## SERVICE BULLETIN

**APPLICABILITY:** 2012-13MY Impreza 2.0L NA Models  
2014MY Forester Models

**NUMBER:** 12-174-14

**SUBJECT:** Instrument Panel Side Vents Coming Loose

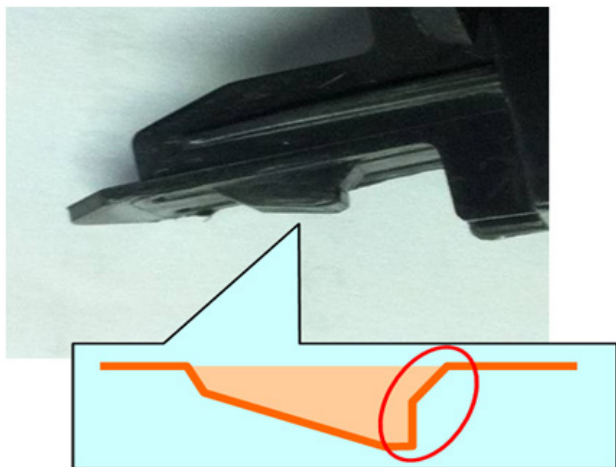
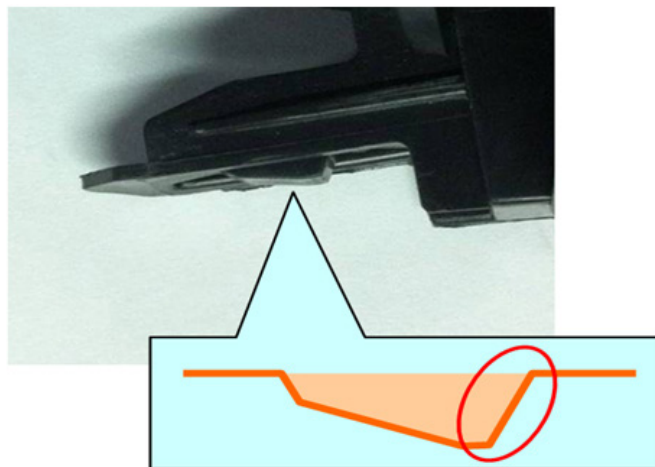
To address customer concerns of the instrument panel side dash grille vent assembly coming loose, the retaining claw portion has been redesigned to provide better retention.

After Design Change

Before Design Change

Should you encounter a complaint of the side grille vent(s) being loose, replace the loose vent with one which has the new design retaining claws. There has been no change to the current Service Manual procedure for grille vent replacement.
